Anders Lasater Architects, Inc.
384 Forest Avenue, Suite 12
Laguna Beach, CA 92651
949.260.7837, Office
949.457.1827, Office
anders@anderslasaterarchitects.com

D'Eliscu Residence
013-2015
New Single Family Home
1011 Kings Road
Newport Beach, CA 92663

A6.5

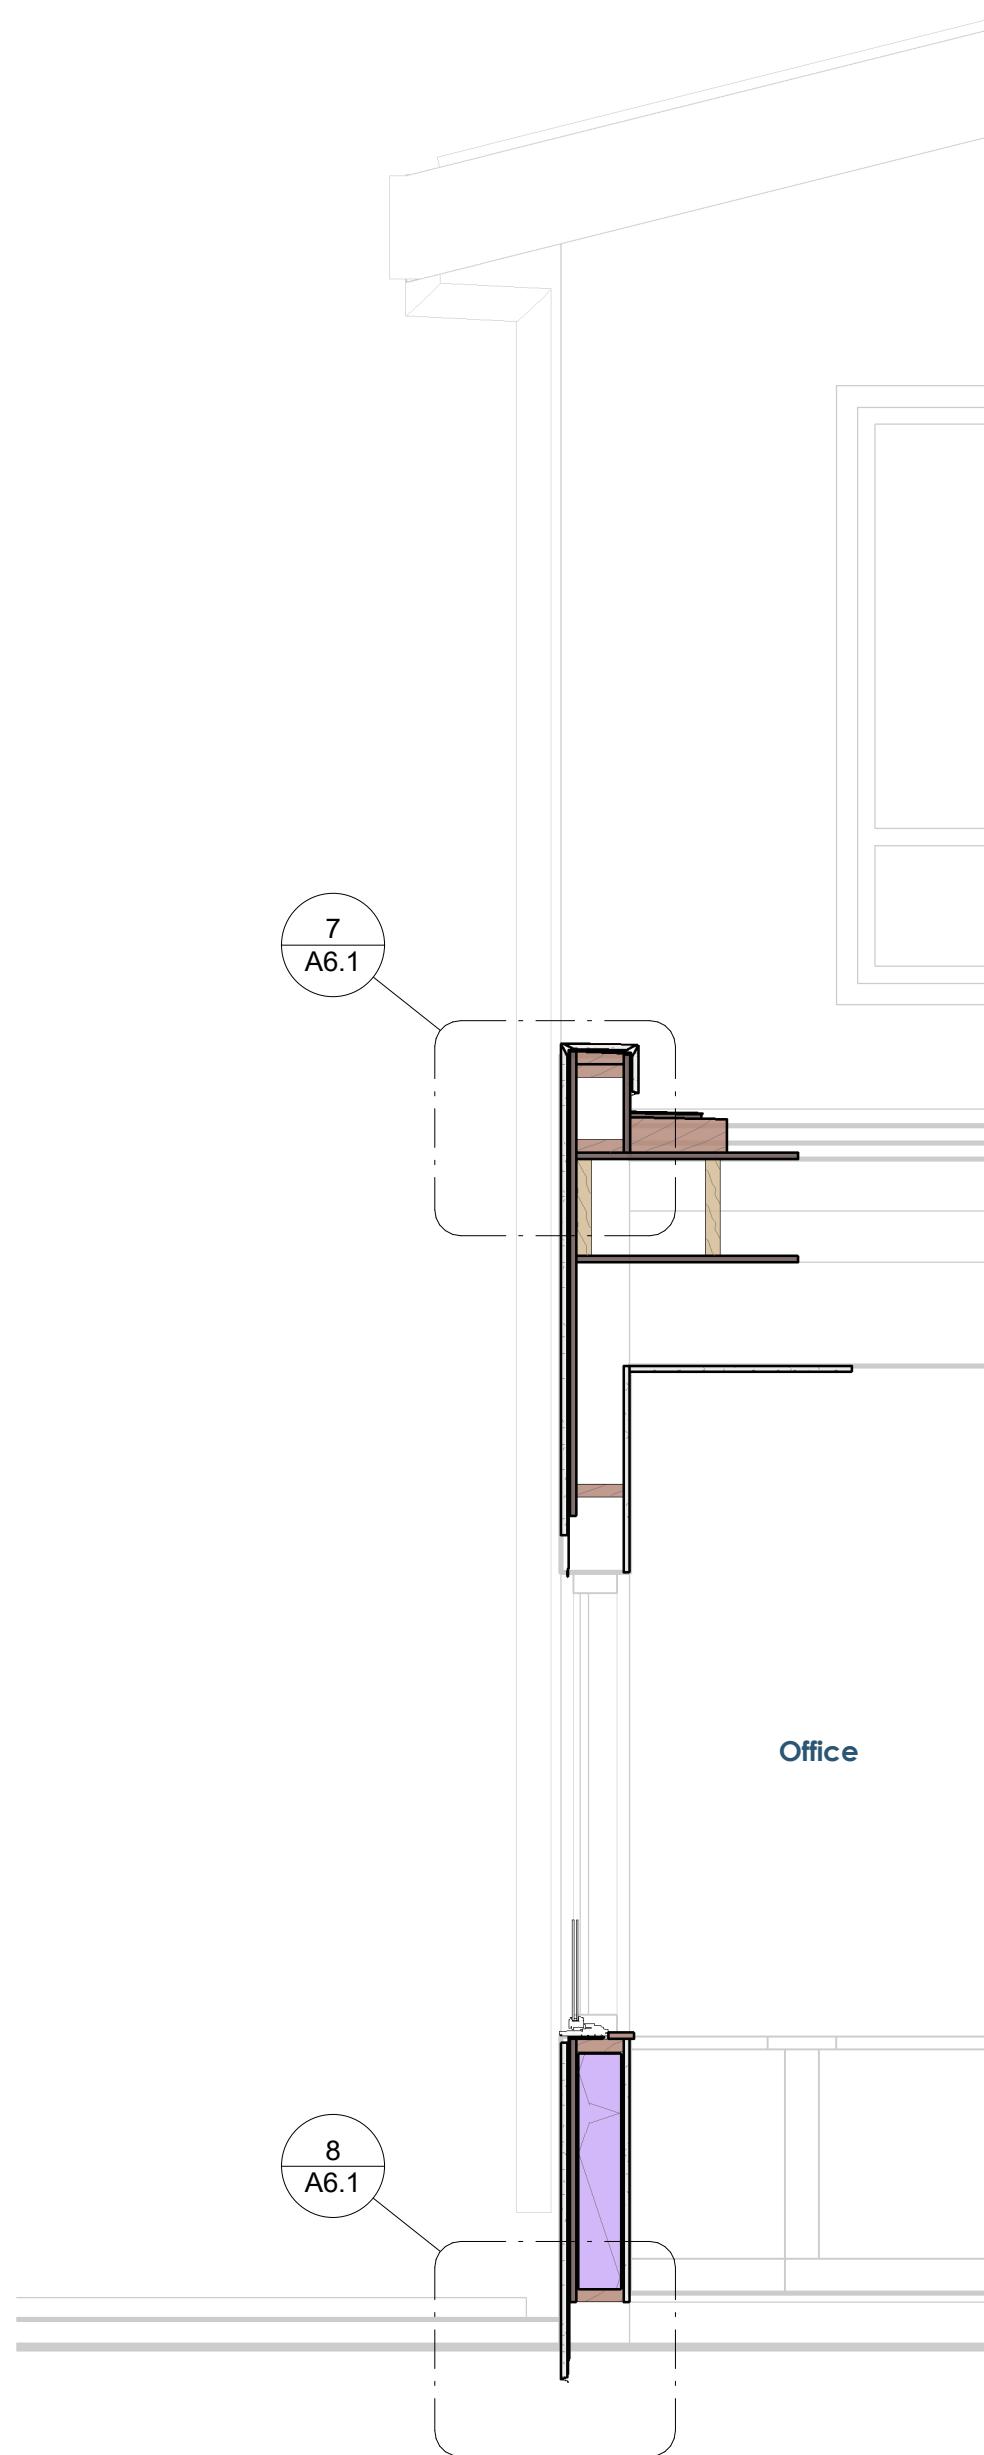
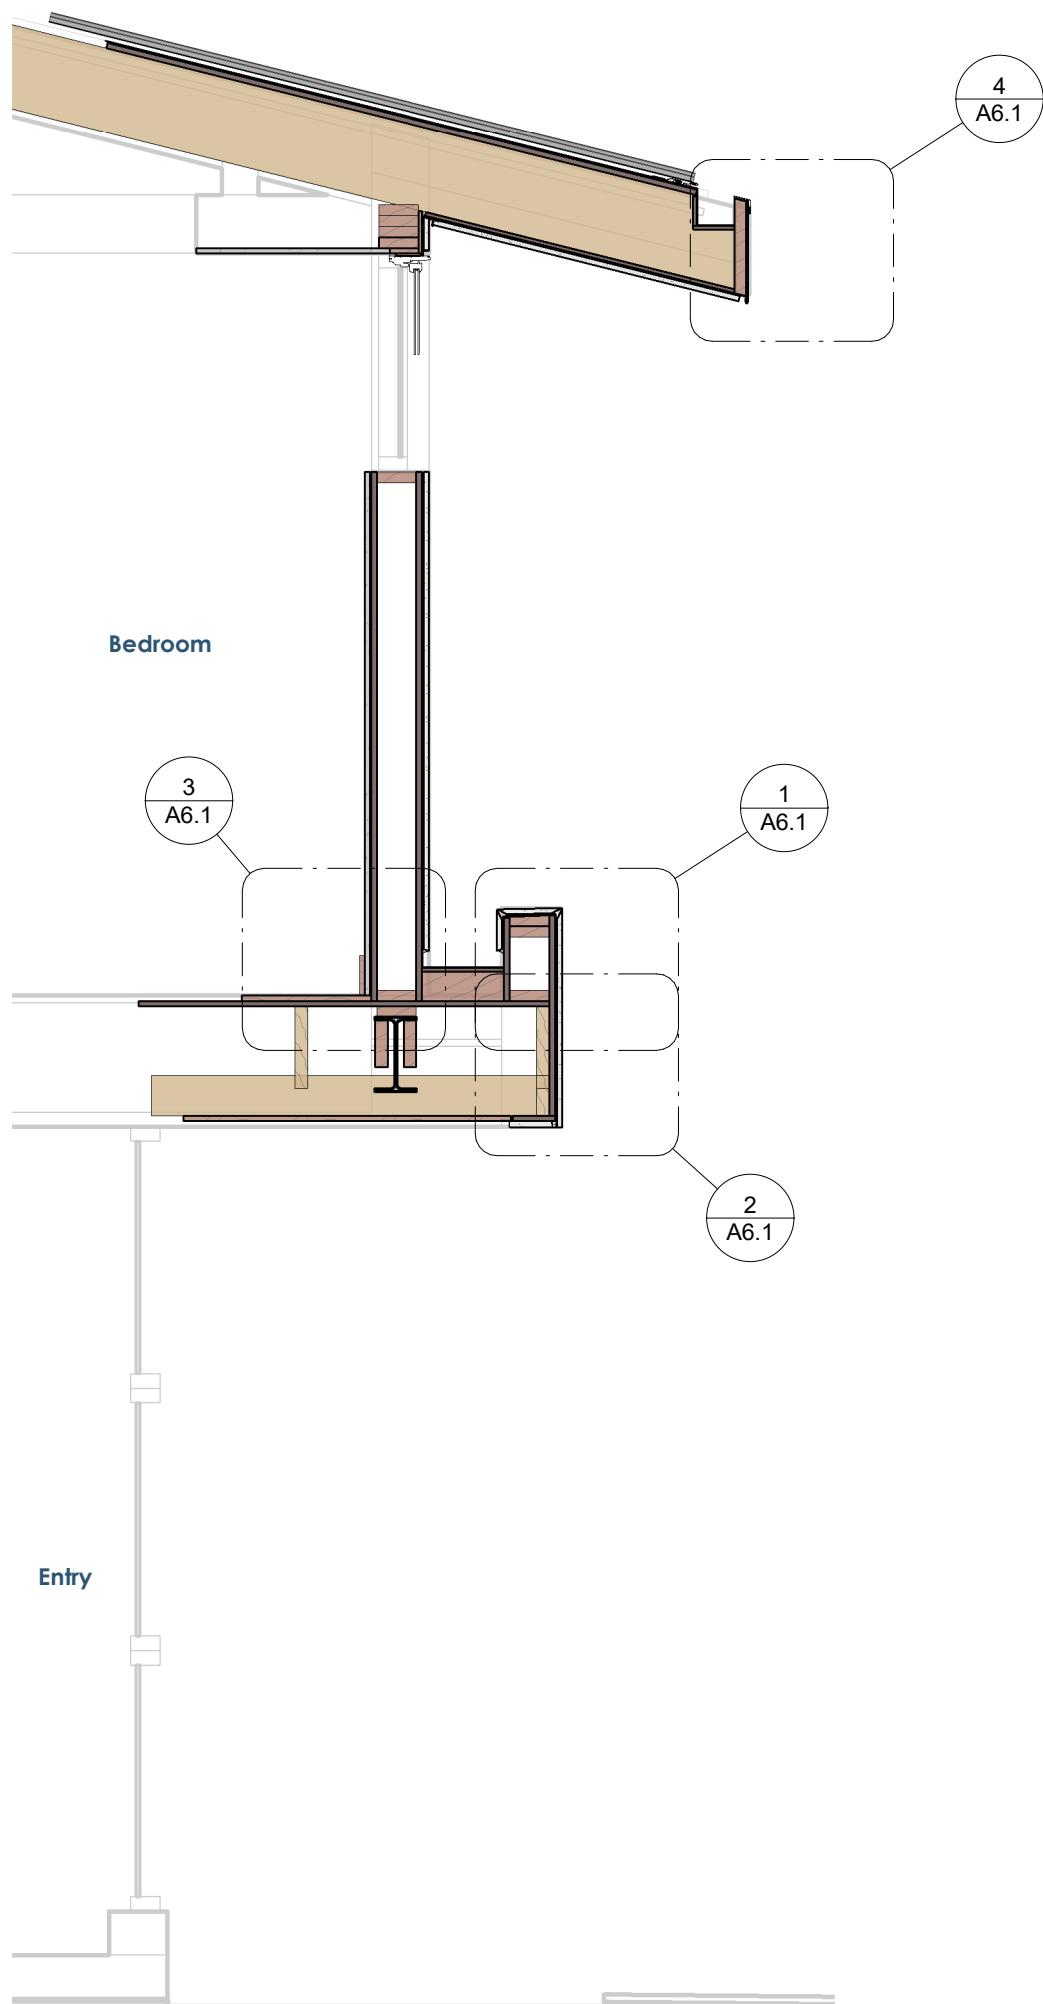
you mentioned a scupper here. Were you thinking it would notch into the beam?

If not, the bottom of the scupper would be at the top of the finish floor inside...

That is, water would run inside the house before the scupper was engaged.

Please advise

even if we locate a slot drain here, I think we might have to notch into the top of the joist. That okay? Not much depth to work with.

I mentioned scuppers as the overflow for the deck drain system. As I understand it we need to have an overflow 2" higher than the deck drains, correct? Otherwise, do you have thoughts on how to achieve overflow?

show it notched as needed for now. We can coordinate that with the engineer once we understand the depths needed. Thanks.

will introduce a slot drain on next iteration
